Subject: Review meeting 7/16/19 Lavitt property PV Planning from Phil Hagenah

Re: Preliminary Plat for Lavitt Manor II—Two Lot Subdivision: 7525 N. Ironwood Drive

5. PUBLIC HEARINGS 19-302 CONSIDERATION OF PRELIMINARY PLAT

11
C.3

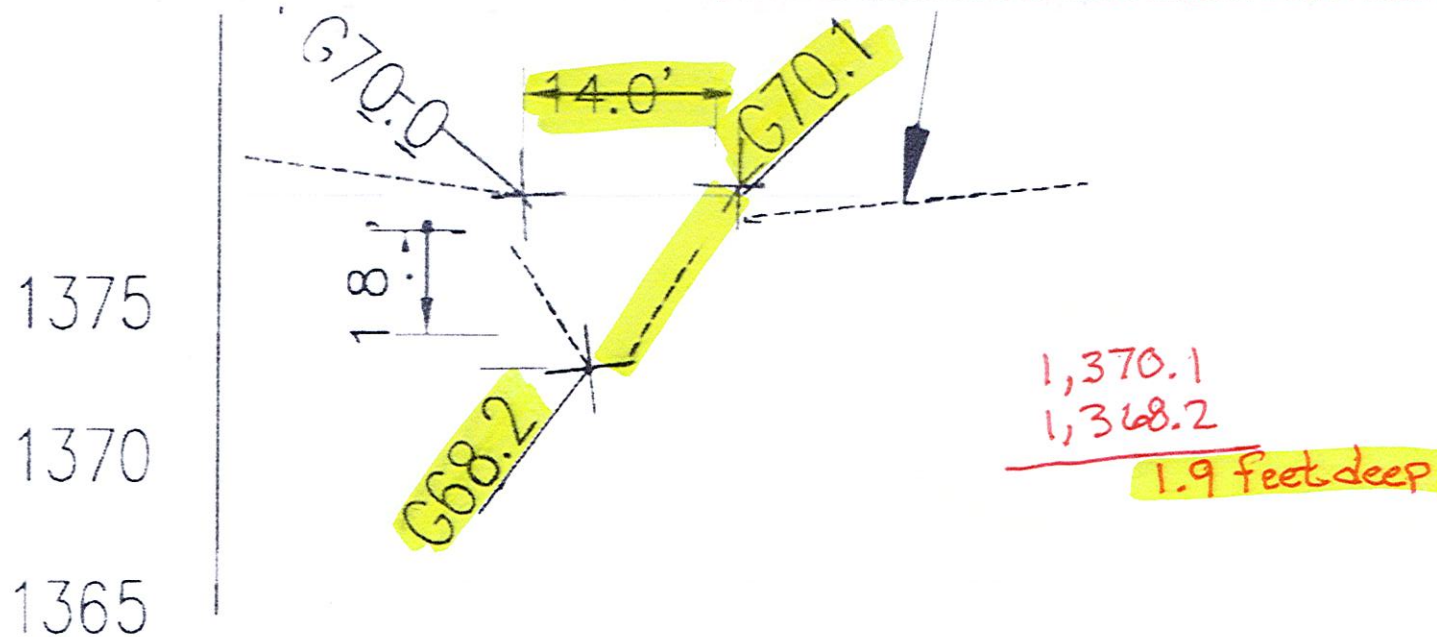
- Must consider both "historical banks" to determine depth;
- Nowhere does it say watercourse depth is taken from one bank, lowest bank, or existing grade of one bank.

- Width must be determined by taking a measurement at the "top of the bank":
 - Can only mean at the top of each bank, or one could not obtain a width measurement from one bank.
- Accordingly, to ensure the same "top of the bank" meaning throughout the provisions, "top of the bank" must mean top of each bank:
 - Depth measurements must be taken from the top of each historical bank of the wash.

- Width must be determined by taking a measurement "to the top of the bank":
 - Can only mean to the top of each bank, or one could not obtain a width measurement from one bank.
- Accordingly, to ensure the same "top of the bank" meaning throughout the provisions, "top of the bank" must mean top of each bank:
 - Depth measurements must be taken from the top of each historical bank of the wash to determine if it is a Natural Wash.
